South Texas Project Electric Generating Station P.O. Box 289 Wadsworth, Texas 77483

April 14, 2010
U7-C-STP-NRC-100083

South Texas Project
Units 3 and 4
Docket Nos. 52-012 and 52-013
Supplemental Response to Request for Additional Information

1. Supplemental Information Dates
2. RAI 03.07.01-24, Supplement 1
3. RAI 03.08.01-8, Supplement 1
4. RAI 03.08.04-25, Revision 1
5. RAI 03.08.05-2, Revision 1
6. RAI 03.08.05-3, Revision 1

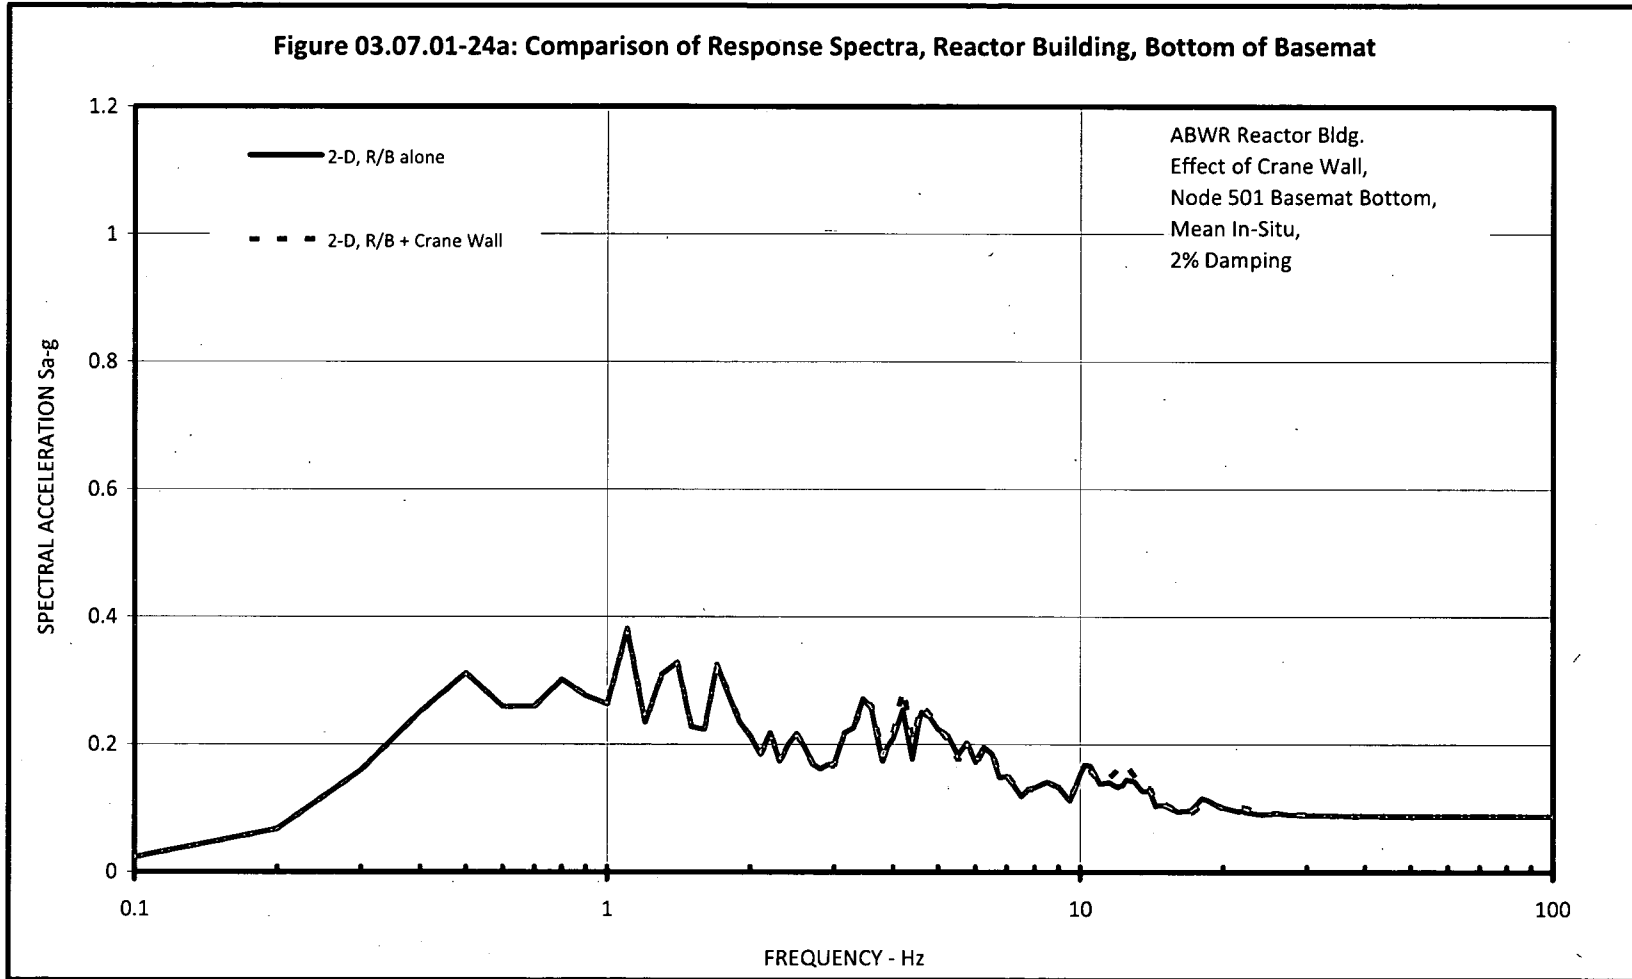
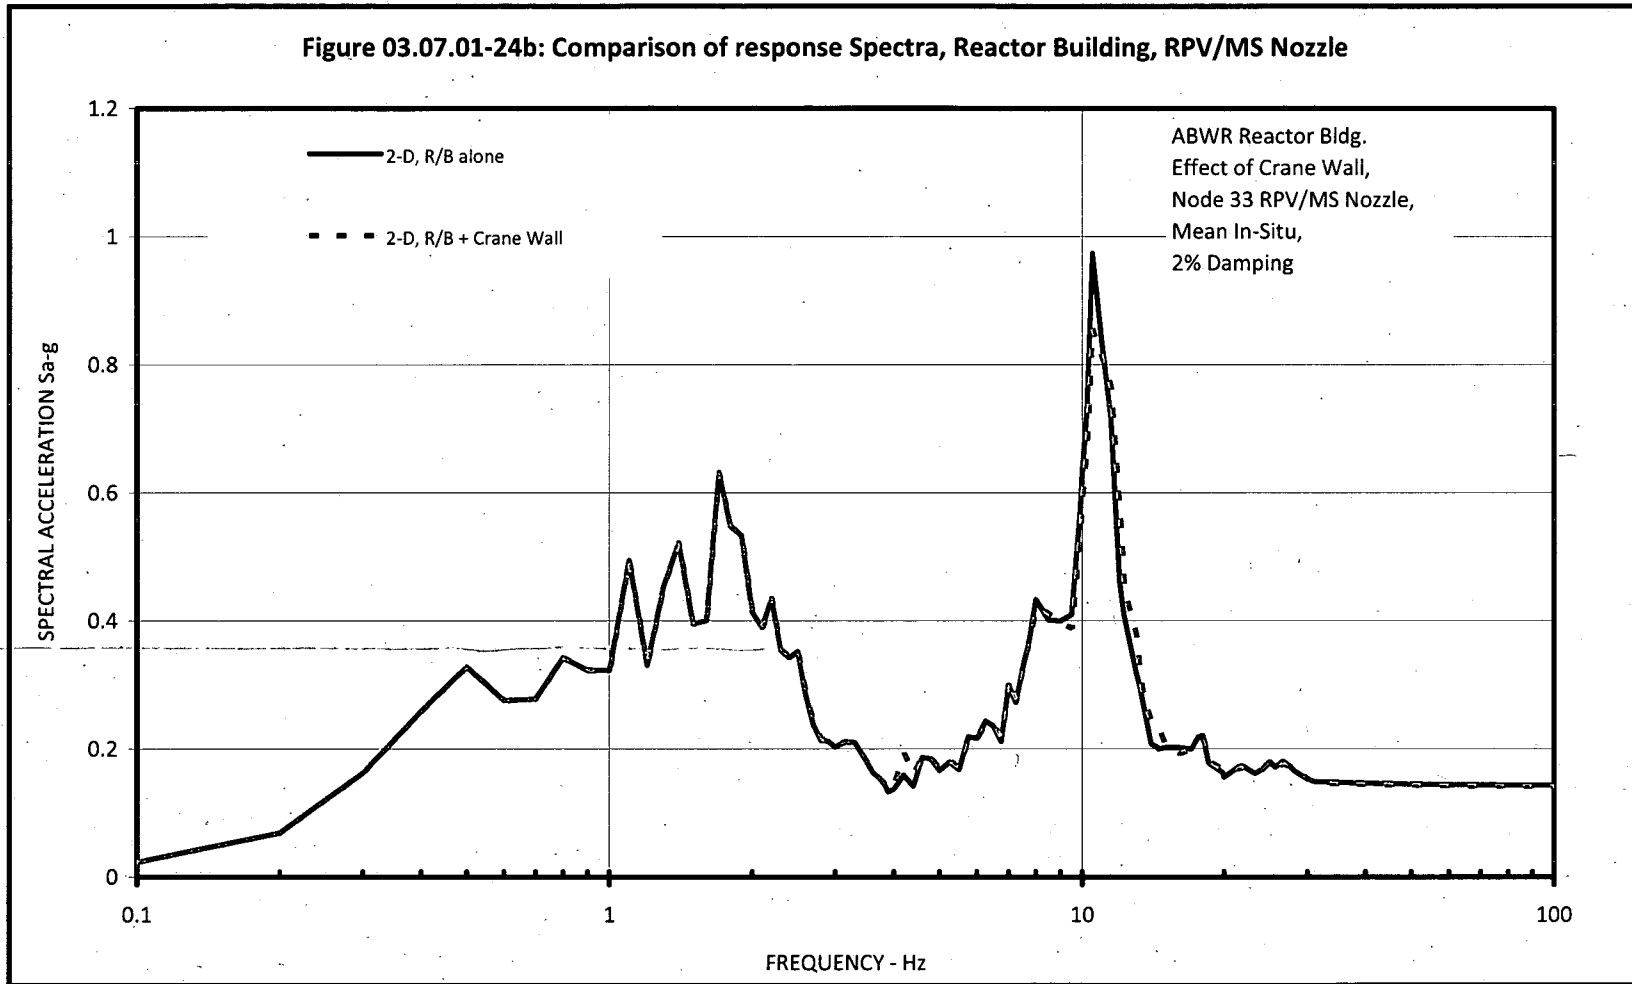
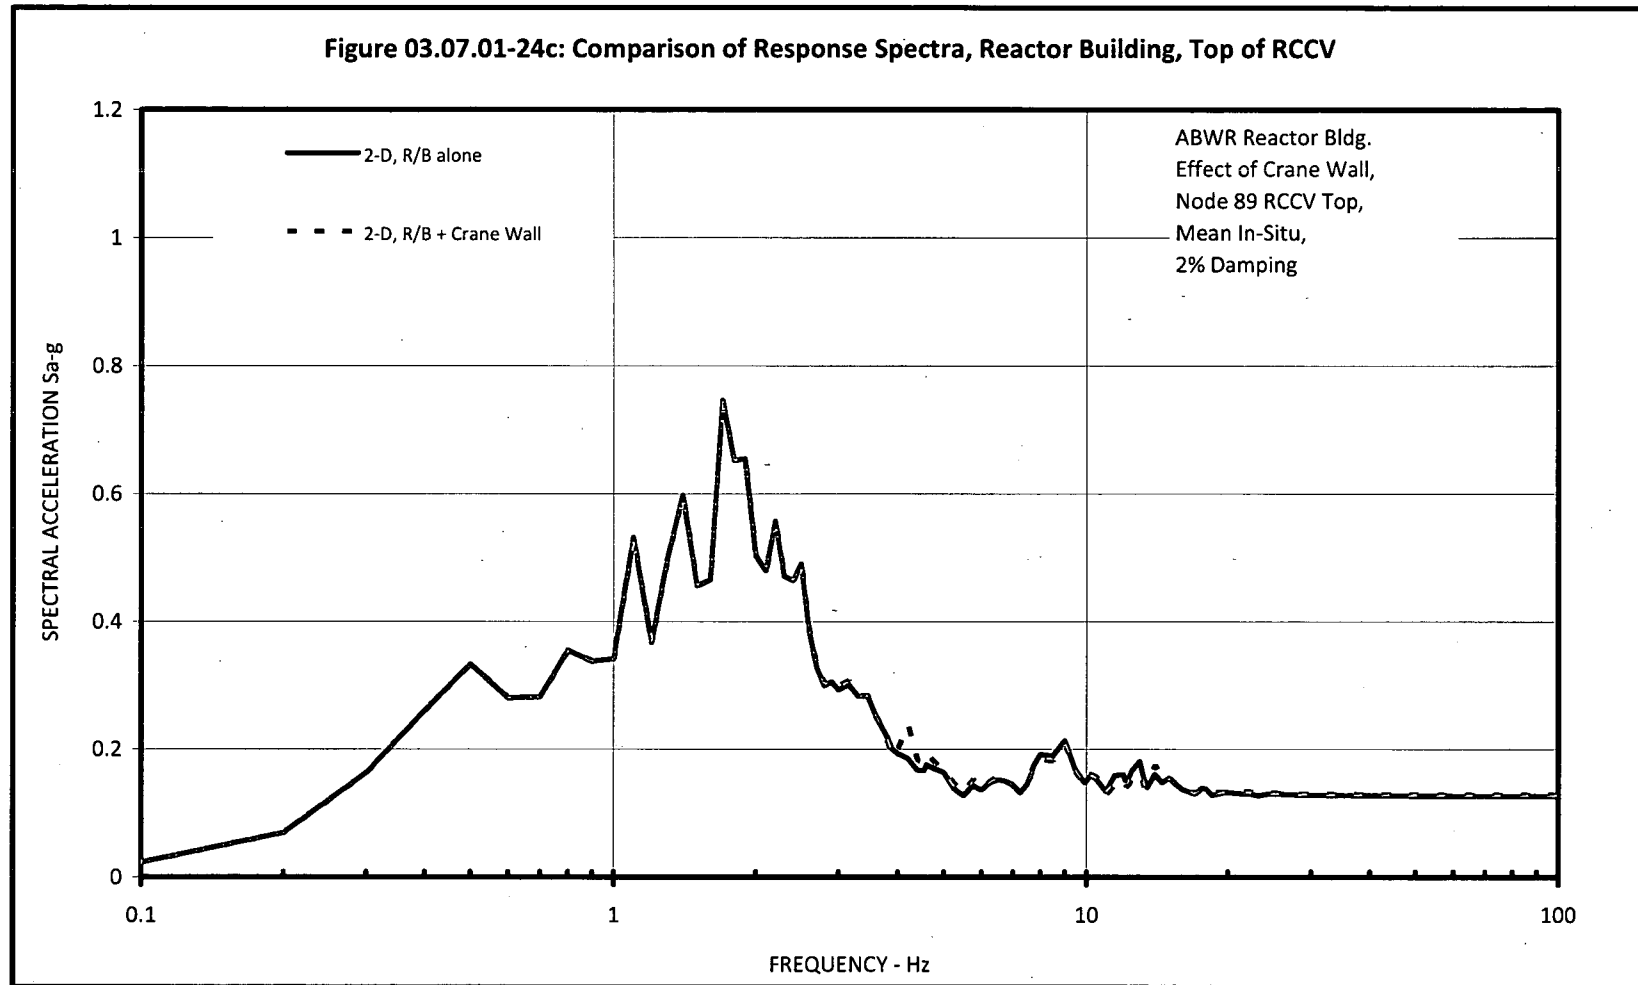
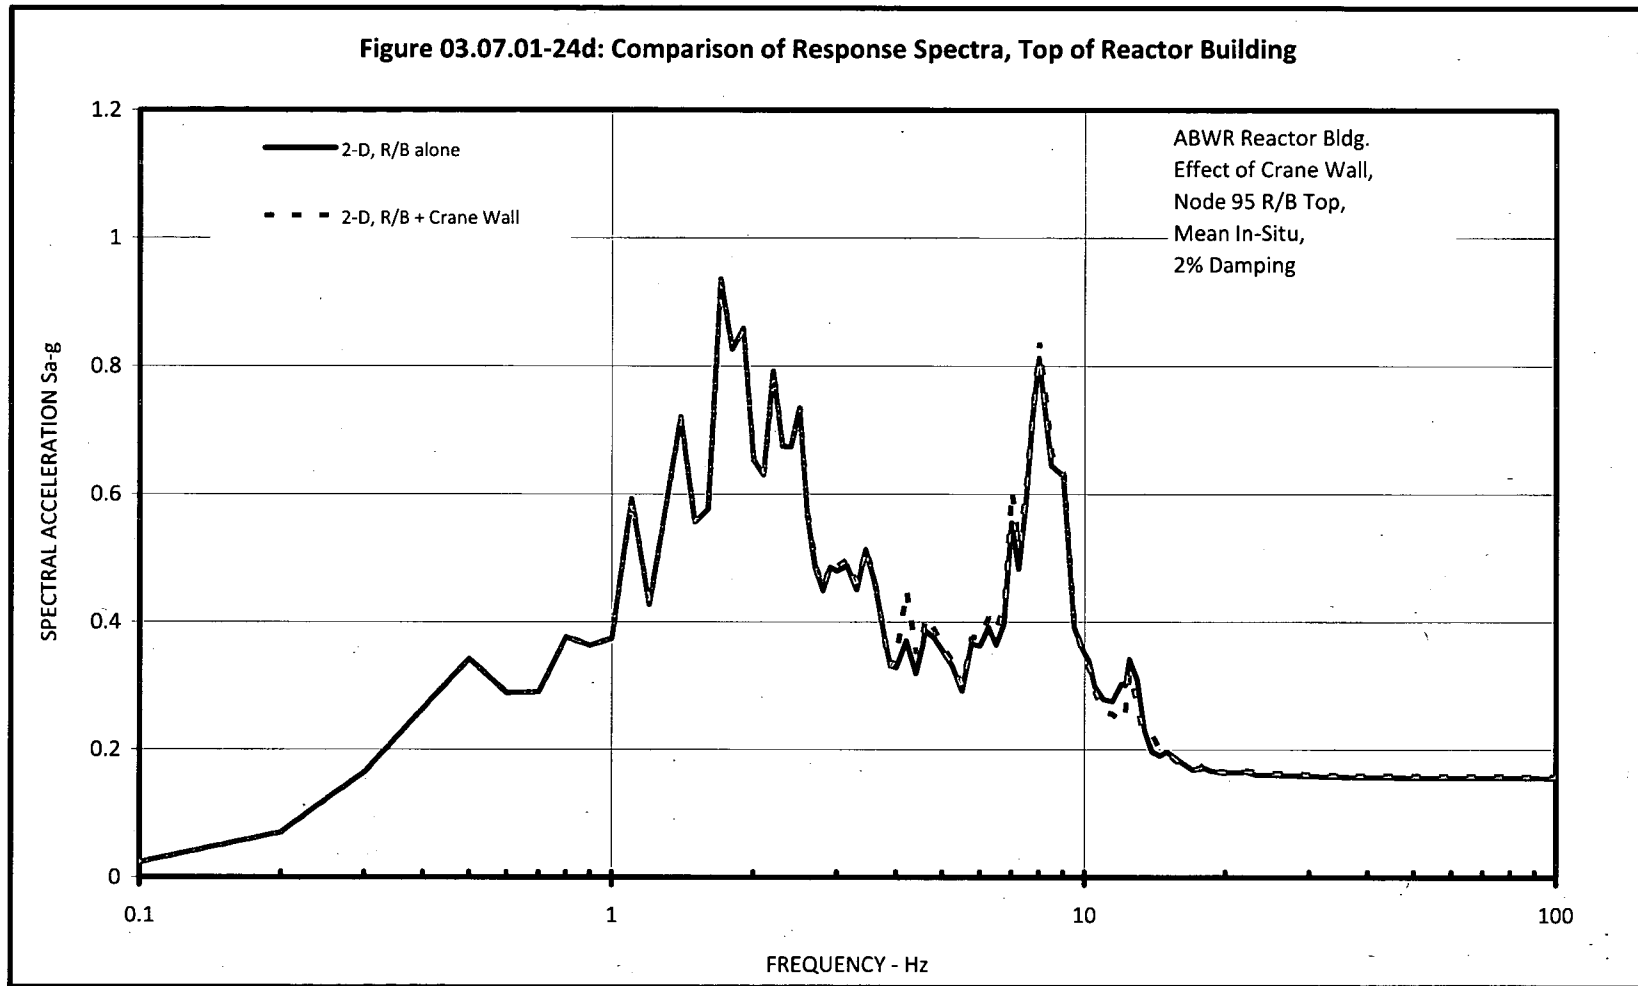
1. In the response to RAI 03.07.01-14, Item 1, the applicant cited DCD Appendix 3A in concluding that "... *the potential effect of structure-to-structure interaction was relatively small.*" However, DCD Section 3A.9.7, "Effect of Adjacent Buildings" also concluded that seismic soil pressure in between the RB and CB increased due to structure-to-structure interaction (SSSI) effect. As such the applicant is requested to discuss how the potential effects of increase in the seismic soil pressure in between the Category 1 structures and the retaining wall due to the SSSI effect has been addressed and bounded by the certified design.

2. In the response to RAI 03.07.01-14, Item 2, the applicant stated in the second bullet that "*In comparison to the Reactor, Control and Turbine Buildings, the retaining wall is a light structure and a lighter structure will have less influence on the seismic behavior of the heavy adjacent structures.*" While the inertia of the RC retaining wall is not expected to affect the seismic response of the adjacent seismic Category I structures, the stiff retaining wall can act as a barrier to reflect the seismic waves due to kinematic interaction with surrounding soil and could affect the seismic input to the adjacent structures. As such, the applicant is requested to provide a quantitative assessment of the effect of RC retaining wall on the SSI analysis of adjacent Reactor and Control Buildings.

In order to address the above two questions, a soil-structure interaction (SSI) analysis of the Reactor Building (RB) and Control Building (CB), with and without the crane wall, was performed for the site-specific conditions, including site-specific safe shutdown earthquake (SSE) and soil properties. These analyses were performed using two-dimensional (2D) models of the RB and CB. The SSI analyses were performed using the SASSI2000 program. Summaries of the SSI analyses results for the mean soil case are presented below. Similar results are obtained for lower and upper bound soil cases.

- Table 03.07.01-24a compares the maximum forces and moments, at key locations of the RB, with and without the crane wall. As can be seen, the crane wall has a negligible effect on the resulting maximum forces and moments.
- Figures 03.07.01-24a through 03.07.01-24d provides comparisons of response spectra at several locations with and without the crane wall. As can be seen, the crane wall has a negligible effect on the resulting spectra.
- Figure 03.07.01-24e provides the comparison of the resulting seismic soil pressures from the SSI analyses with and without the crane wall. As expected, these seismic lateral soil pressures are significantly bounded by the design seismic soil pressure per DCD Tier 2, Figure 3H.1-11 and pressure obtained from the alternate modified Ostadan method described in COLA Part 2, Tier 2, Section 2.5S.4.10.5.2.

Figure 03.08.01-8A DCD Pool Swell Load

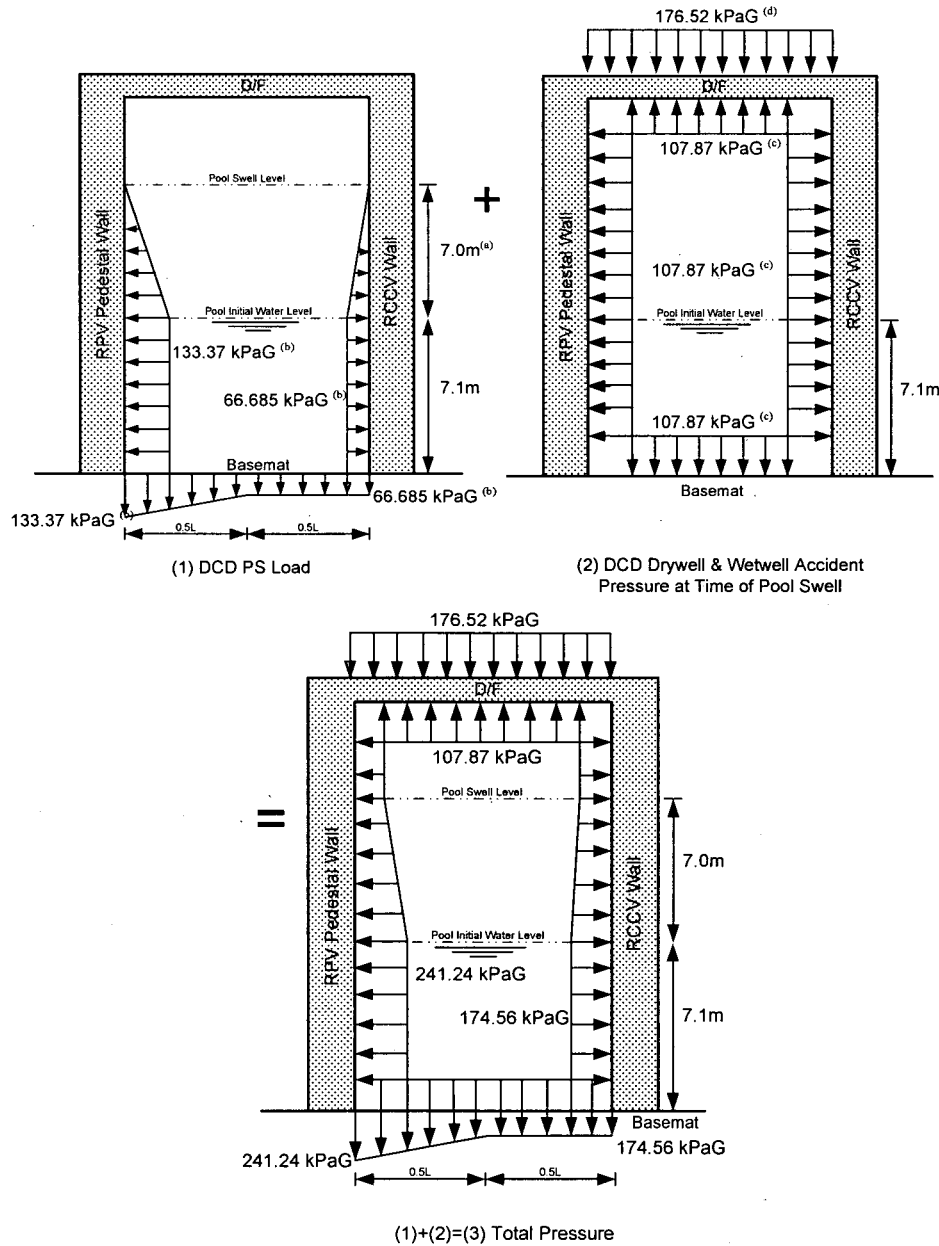
The applicant's response to Question 03.08.01-5 states that the changes in loads on the containment internal structures due to the increase in pool swell height and pressure will be addressed during the detail design phase. However, ABWR DCD Subsection 3H.1.5.5.2 describes the design of the containment internal structures, load combination (including pool swell loads), and analysis and design results. These are incorporated by reference in FSAR Section 3H. Also, pool swell loads are used in loading combinations for design of the containment structure, and analysis and design results for the containment structure are reported in Appendix 3H. Since the changes in loads due to increases in pool swell height and pressure on the concrete containment and containment internal structures are not addressed at this time, the applicant is requested to provide a quantitative evaluation and confirm that the increased pool swell height and pressure will not have an adverse impact on the design of the concrete containment and the containment internal structures, and that it is appropriate to incorporate by reference the analysis and design results for the containment and the containment internal structure reported in Appendix 3H of ABWR DCD.

The effect of increased pool swell (PS) height and pressure has been evaluated. The results of the evaluation confirm that the increased pool swell height and pressure will not have an adverse impact on the design of the concrete containment and the containment internal structures, and that it is appropriate to incorporate by reference the analysis and design results for the containment and the containment internal structure reported in Appendix 3H of the ABWR DCD. The design of the Reinforced Concrete Containment Vessel (RCCV) and internal structures, as described in ABWR DCD Section 3H.1.5, considered selected load combinations as delineated in ABWR DCD Tables 3H.1-5a and 3H.1-5b. In these load combinations, Condensation Oscillation (CO) was considered to be the controlling loss-of-coolant accident (LOCA) (CO, Chugging (CH), or PS) load, as these three LOCA loads do not occur simultaneously. For the containment and containment internal structures described in ABWR DCD Sections 3H.1.5.5.1, 3H.1.5.5.2, and 3H.1.5.5.3, the load combinations including CO + Pa (Pa is the containment pressure associated with the LOCA) loads governed over the load combinations including PS + Pa loads, as shown in Figures 03.08.01-8A (which shows the magnitude and distribution of the DCD PS and Pa loads) and 03.08.01-8B (which shows the

magnitude and distribution of the CO and Pa loads). It has been concluded that the load combinations including CO + Pa loads still govern over the load combinations including the revised PS + Pa loads, as shown in attached Figures 03.08.01-8B and 03.08.01-8C (which shows the magnitude and distribution of the revised PS and Pa loads). A summary of the comparison, based on the data from Figures 03.08.01-8A through 03.08.01-8C, is included in the table below:
